ENGINEERING CHANGE NOTICE
DART AEROSPACE LTD

Date: 19.03.01	Job No.: RB18-AGUSTA	ADR Yes/No: N	ADR Date: <i>mpp</i>
Product No.: DART TOOLING AGUSTA	Created By: VM	Approved By: <i>WJ</i>	ECN #: 19- 588
Product Name: T/R FLAPPING LOCKING TOOL	Checked By: <i>helt</i>

Reason for Change:
CUSTOMER ISSUE / FIT ISSUE

TITLE
T/R FLAPPING LOCKING TOOL

TOOL PART #
RBW6705G00632-3G

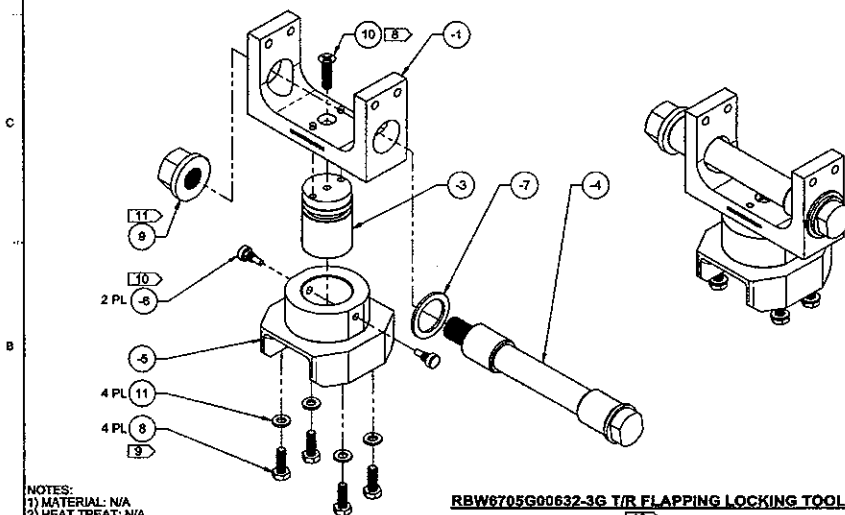
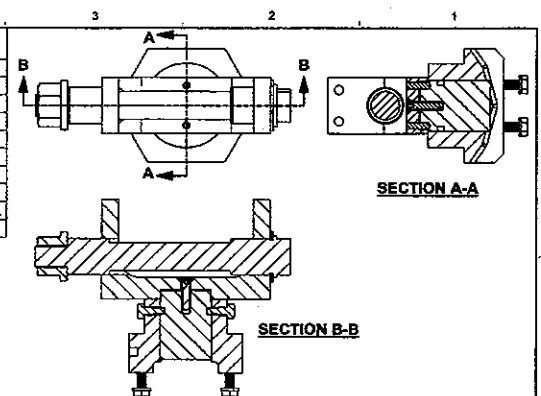
SEE OLDER PDF FOR MORE INFO.
TEMPLATE UPDATED PER DART HBY STANDARDS.
ITEM -1 CHANGED FOR ITEM -2.
ASSY -1 ADDED, IS YORK ASSY
ITEM -5 CHANGED FOR ITEM -4.

ITEM -7 CHANGED FOR ITEM -6.
ITEM -8 CHANGED FOR ITEM -9.
ITEM -11 CHANGED FOR ITEM -7.
ITEM -19 BICMASTER-CARR #90220M430 CHANGED FOR ITEM 12
NAS1149F0463P

ITEM -17 CHANGED FOR ITEM 8.
ITEM -21 CHANGED FOR ITEM 9.
ITEM -18 CHANGED FOR ITEM 10.
ITEM -13 BICMASTER-CARR #88361A508 CHANGED FOR ITEM 11
McMaster#9030A507
ASSEMBLY NOTES: ADDED ON SHEET 1

ITEM -1 DIMENSION WAS 1.125 IS 1.125 ± 0.001 , DIMENSION WAS 1.37501.374 IS 1.3751.373, ENGRAVING "MADE IN USA" / RBW6705G01451-3G AND SN REMOVED, MATERIAL WAS 6081 CLEAR ANODIZE IS 80817075 RED ANODIZE, DIMENSION WAS 1.174.158 IS 1.175.157

ITEM -3 DIMENSION WAS 1.125 IS 1.125 ± 0.001 , MATERIAL WAS BRASS 360, DIMENSION WAS .510 IS .485 ± 0.002 , DIMENSION WAS 1.2741.2704 IS 1.2711.270, DIMENSION WAS 1.889.1882 IS 1.889.1885, DIMENSION WAS .200 IS .241, 0.02 x 45° CMF -3 PL ADDED, R 0.008 MAX 3 PL ADDED

ITEM -4 ENGRAVING REMOVED, R0.005" MAX 4 PL ADDED, MATERIAL WAS 4140 CAD PLATE IS 4140 (28-32 Rc) BLACK OXIDE, DIMENSION WAS .255 IS .25, DIMENSION WAS 8.870 IS 7.000

ITEM -5 DIMENSION WAS .350 ± 0.003 IS .350 ± 0.002 , DIMENSION WAS 1.4281.420 IS 1.42001.428, .03 x 45° CMF ADDED, MATERIAL WAS 5018 CAD PLATE IS 4140 (28-32 Rc) BLACK OXIDE, ENGRAVING REMOVED

ITEM -6 DIMENSION .01 x 45° CMF ADDED, R0.01 ADDED, MATERIAL WAS BRASS IS BRASS 360
ITEM -7 MATERIAL WAS 1016 BLACK OXIDE IS A36/1016/1020 HR ZINC PLATED TYPE 2

Linda, just reviewed this with Mike and from what we can see is that if the parts have been made with the attached deviations then the parts are ok and do not need to be reworked. Just ensure that the parts were made per deviations.
